Re: Miscellaneous Revisions to previously approved COA -63 MLK Blvd., # 2-0016 -17-006

We are requesting approval of minor revisions for New Construction, 63 Martin Luther King Jr. Boulevard. We feel the revisions are an improvement to the overall aesthetic and minor in overall scope. Both Part 1 and Part 2 review items are modified slightly. As per the previous approval, the building is within the boundaries of the National Historic Landmark District/Savannah Historic Overlay District. The overall footprint of the project does not change. The project will have the same +/- 29,992 square feet and is within a 5-story height zone. The total height of the main body of the building is +/-76'-0 + front parapet. The building will be in a contemporary Art Deco style. The building is at the west axis of Broughton at MLK and is unique in its site location. This project has been continued from 2017 and falls under the requirements of the previous Ordinance. As you are aware, the project received the Part 1 approval on October 9, 2019, and Part 2 approval on May 13, 2020. The project is currently in the site permit process and a site demolition permit has been approved by the city in fall of

1 WALL SECTION @ CURTAIN WALLS A5.4 1/2" = 1'-0"

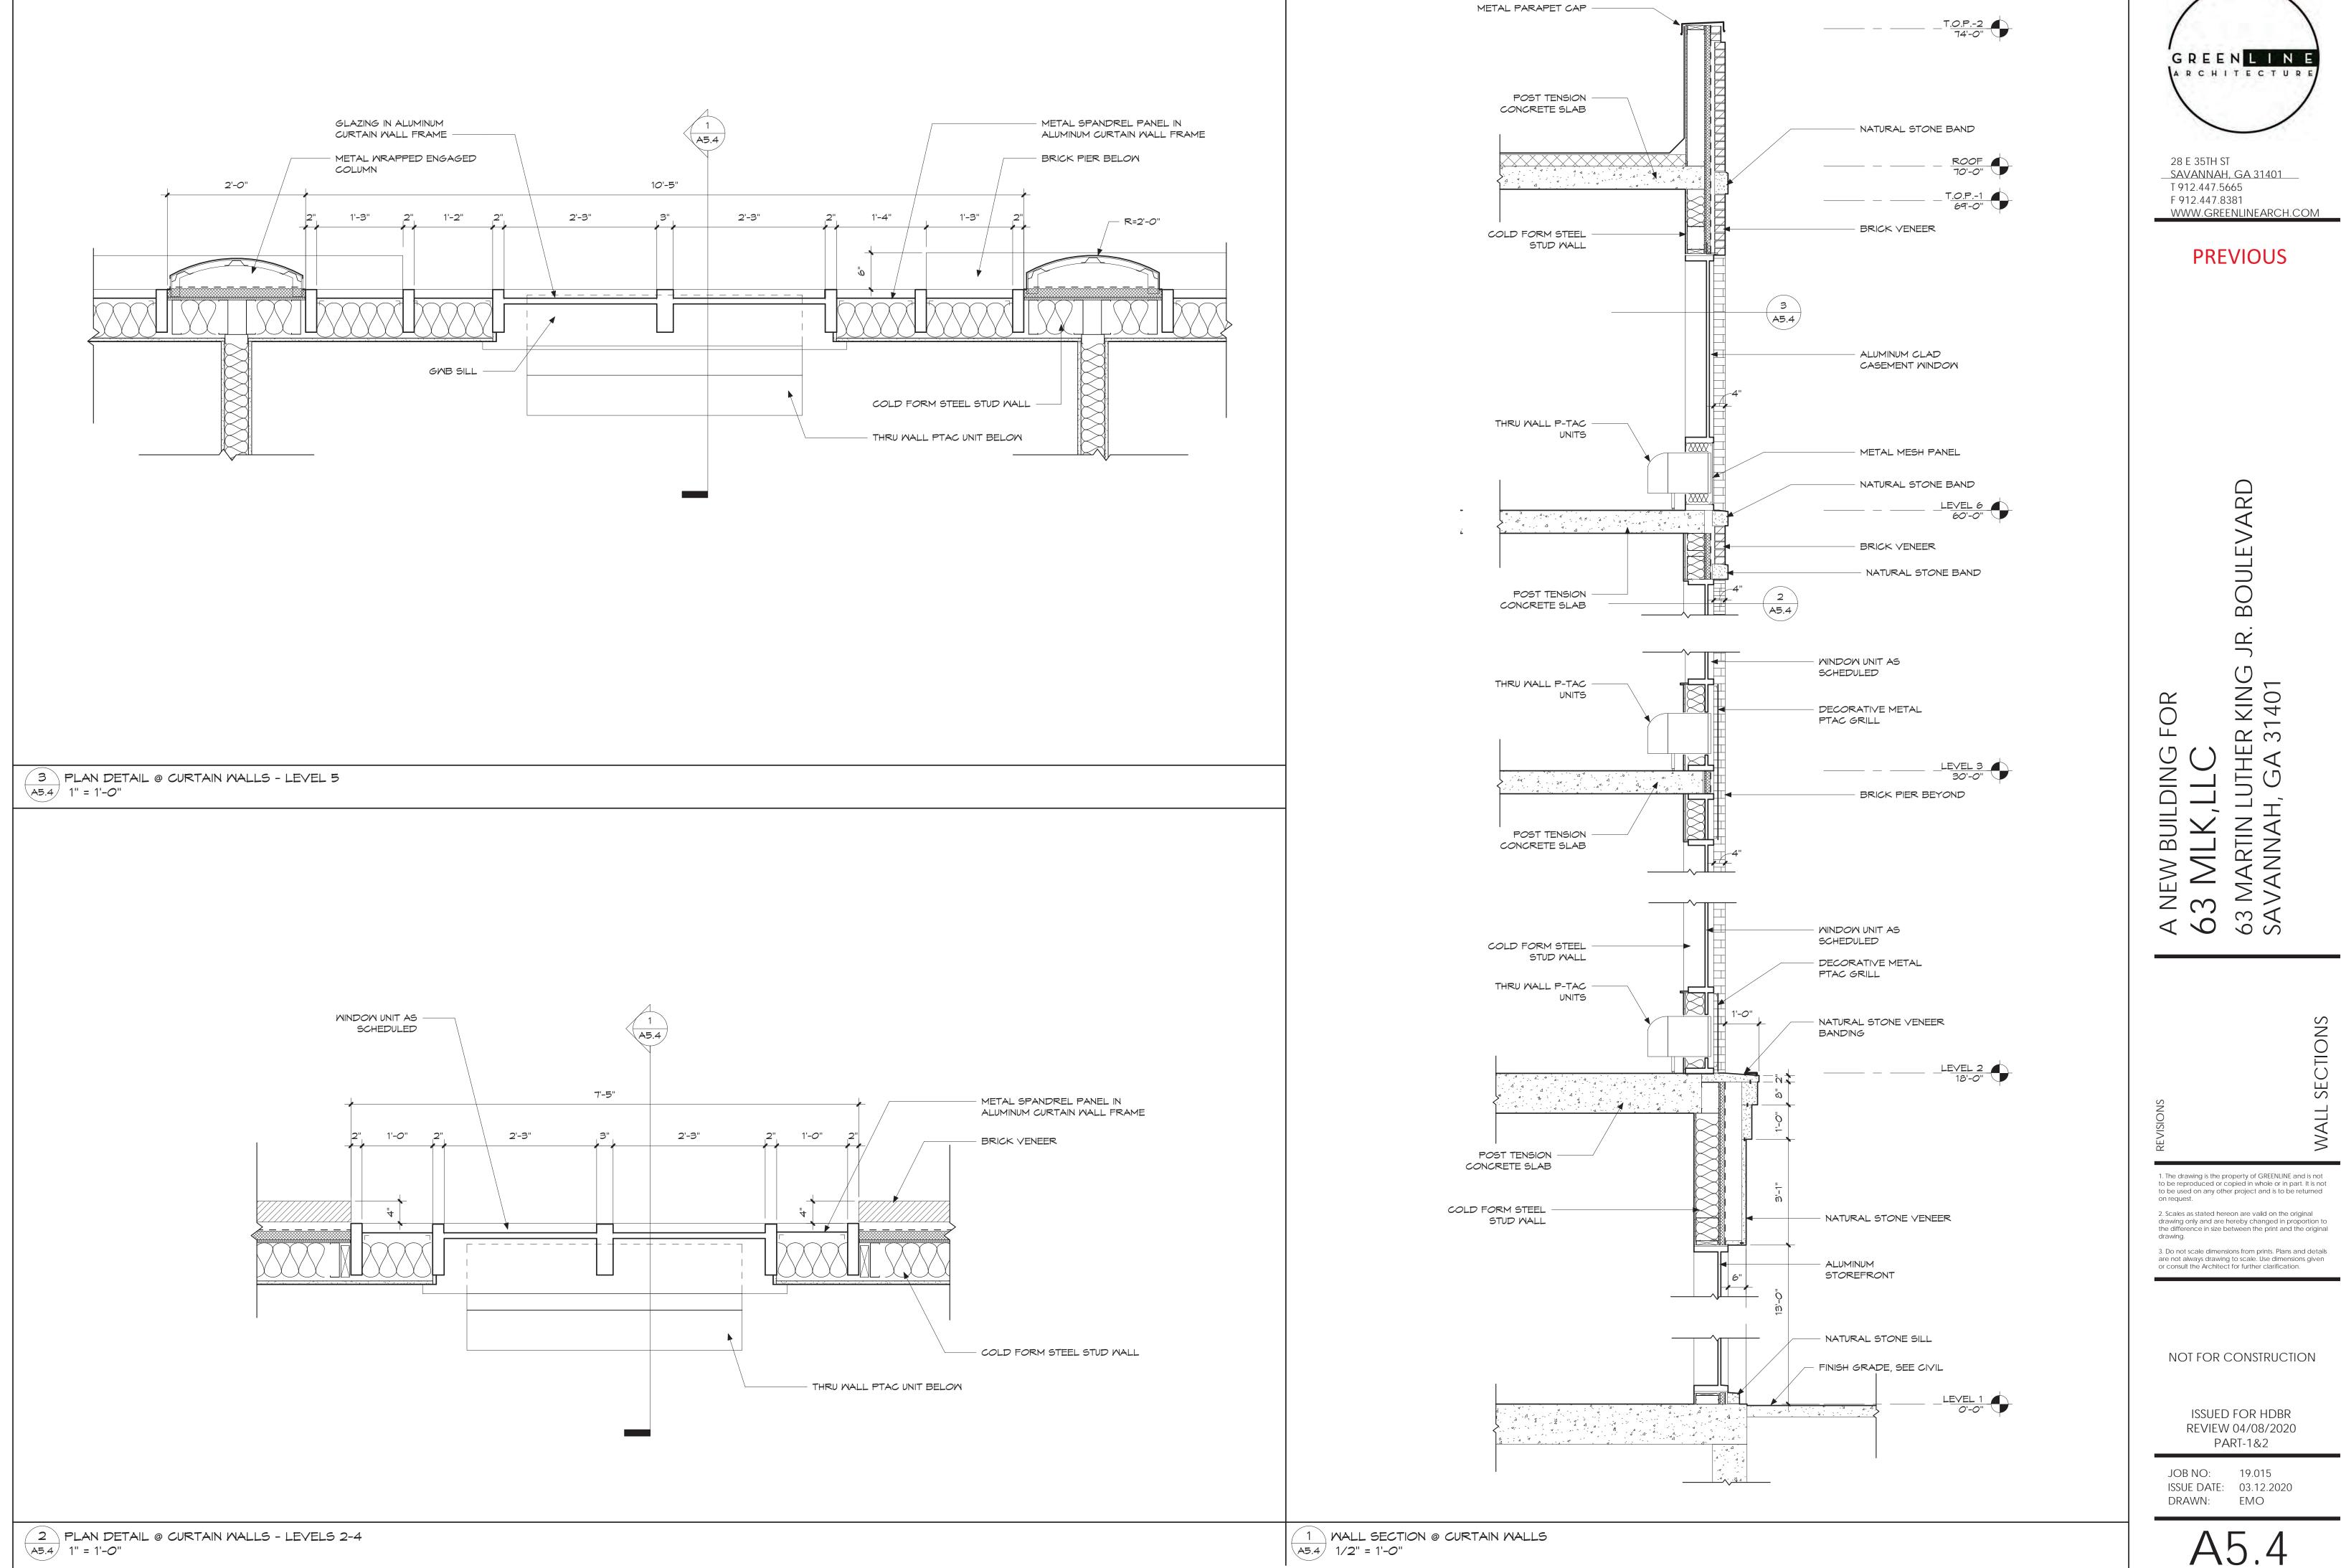
- 4.) The previously approved curtain wall on the south façade has been eliminated; solid brick replaces this wall detail. Window placement is primarily the same on all facades and meets the required criteria.
- 5.) Due to existing site conditions, the west conditions of the site slope is shown with a +/-5'-0 drop to the west, Ann Street. This drop increases the area of natural stone base. Any site conditions regarding ramping will be handled by the site permitting process. If handrails are needed then a selection will be made from city approved standards and will be brought back to you for approval if necessary.
- 6.) Public functions on the ground level are the same, just reworked slightly to branding standards. All exterior doors are in previously approved locations and all open into rooms/public areas as per previously approved, per the intent of the Ordinance.
